SEWAGE DISPOSAL SYSTEM

MARYLAND STATE DEPARTMENT OF HEALTH

P 33257

SUBDIVISION _____ ROAD 11819 Lime Kiln LOT _____

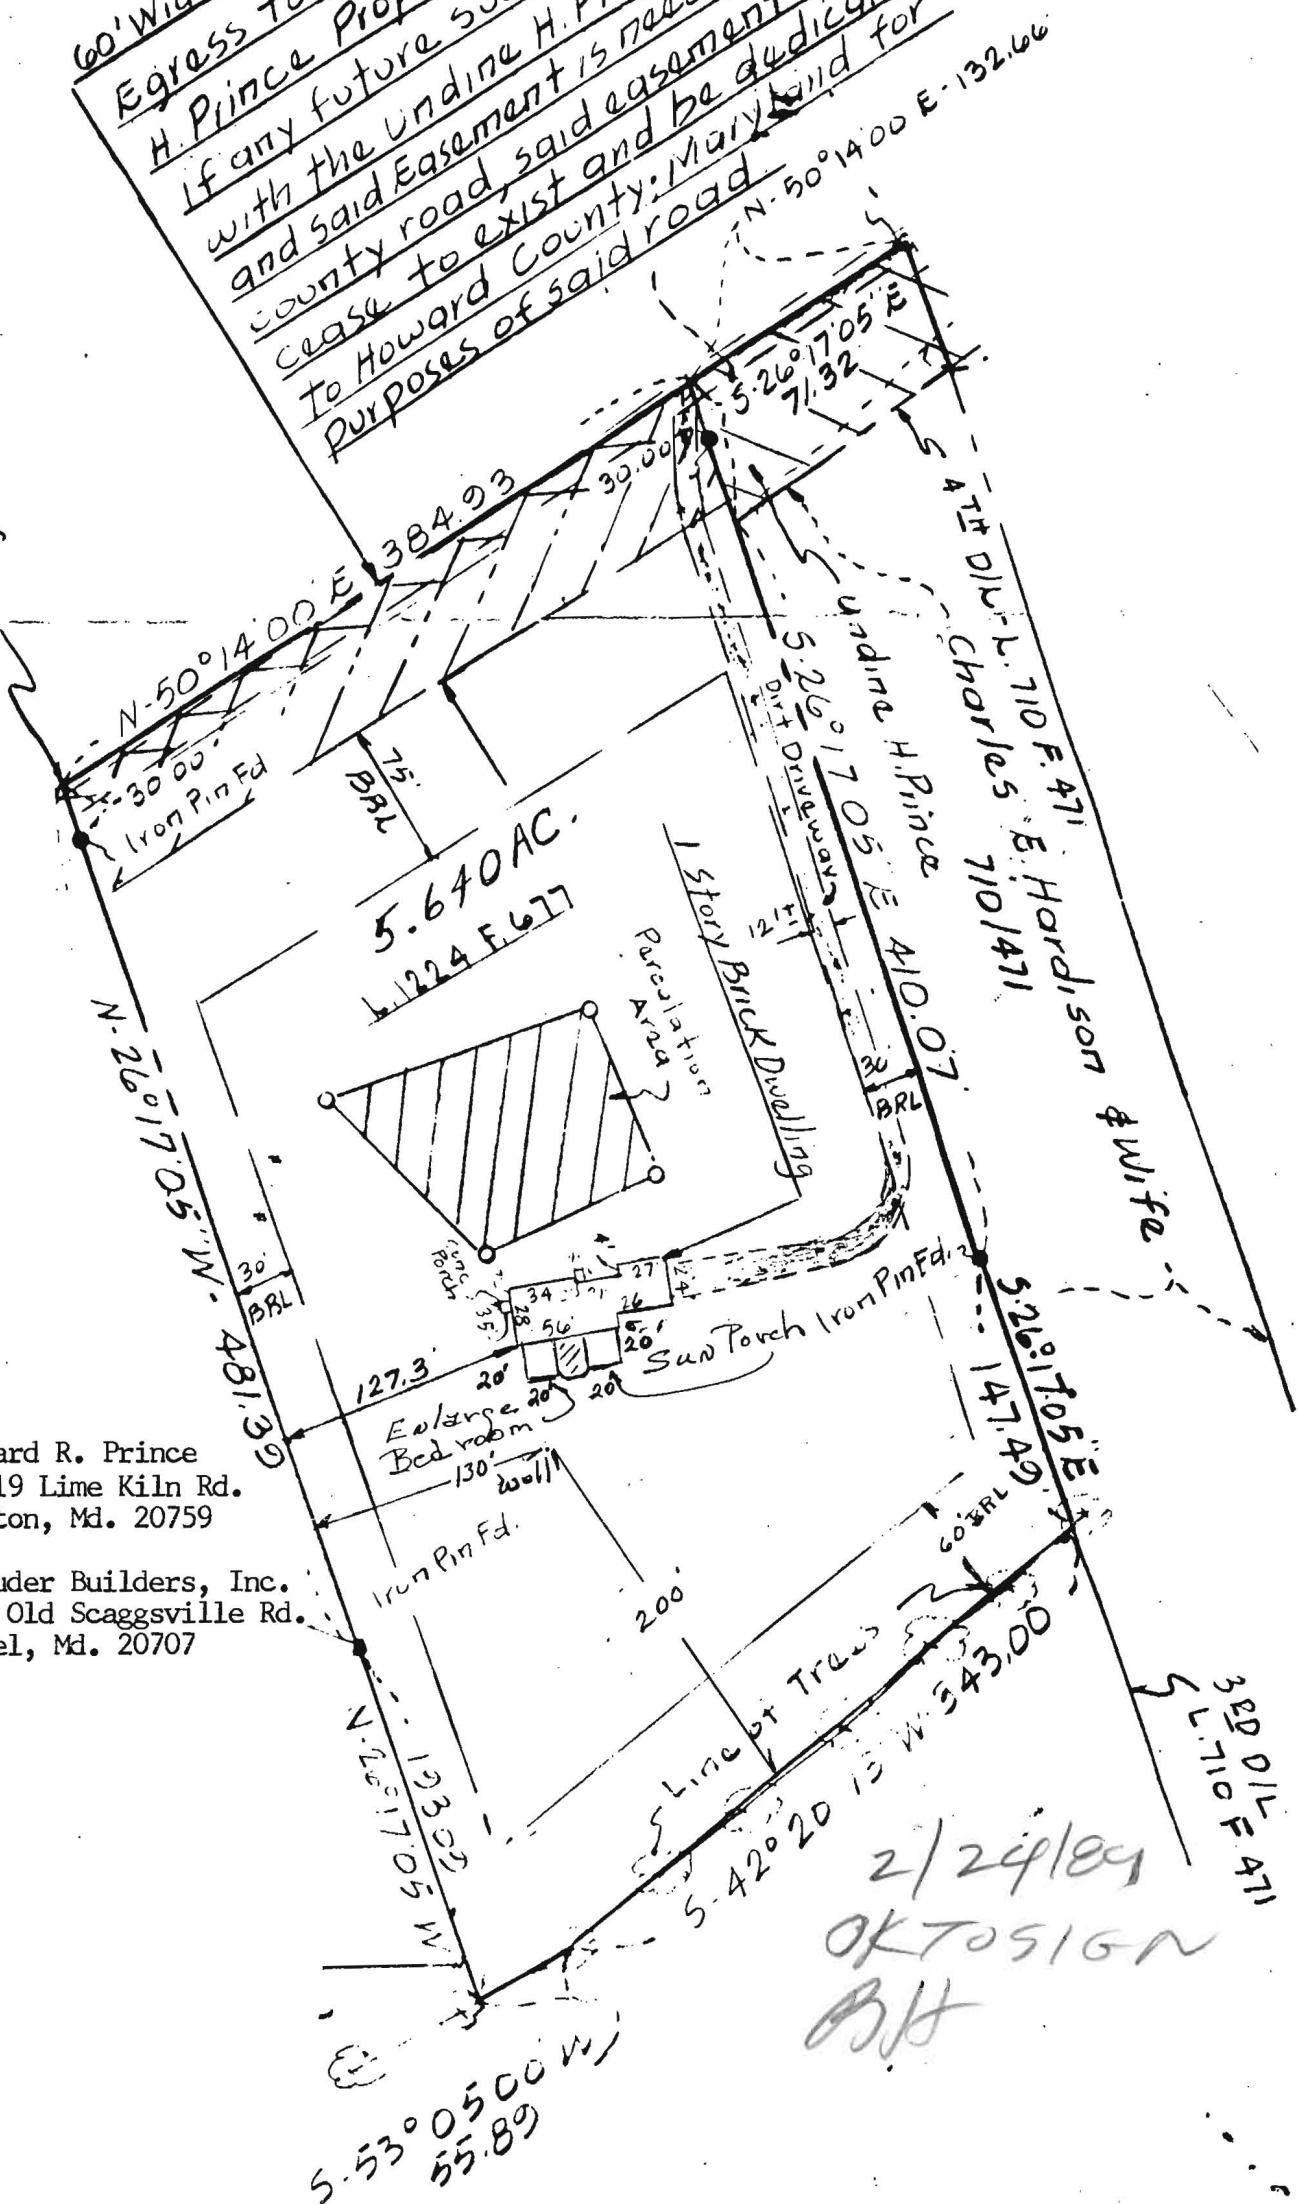
REMARKS 7/16/84 LOCATION OK 3 x 158 = 474 SQ FT

REQUIRED 3 BEDROOM. ADD STONE TO DITCH & HOOK UP TANK

8/3/84 OK to cover all work JS
